**UTAH AIR QUALITY BOARD MEETING**

**FINAL AGENDA**

# Response to Comments

**Figure 1 Speciated Annual Average Light Extinction at Canyonlands**

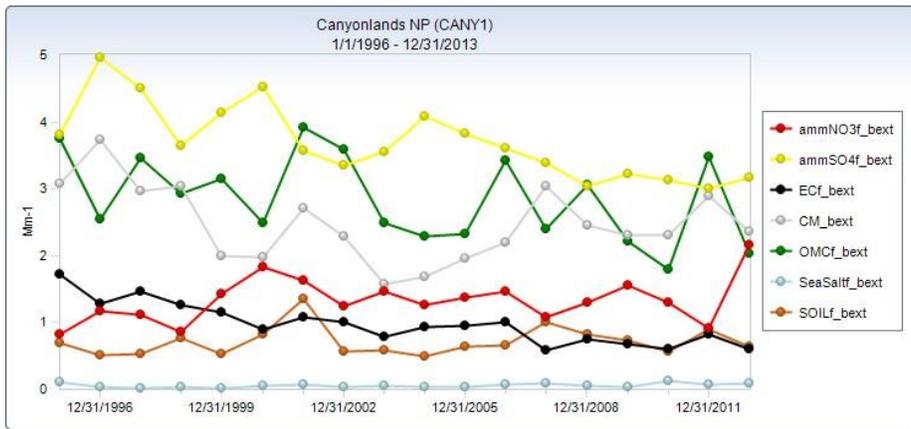
**Commented [A4]:** Superseded by 2011 SIP in relation to NO<sub>x</sub> and PM BART. See subsequent comments here.
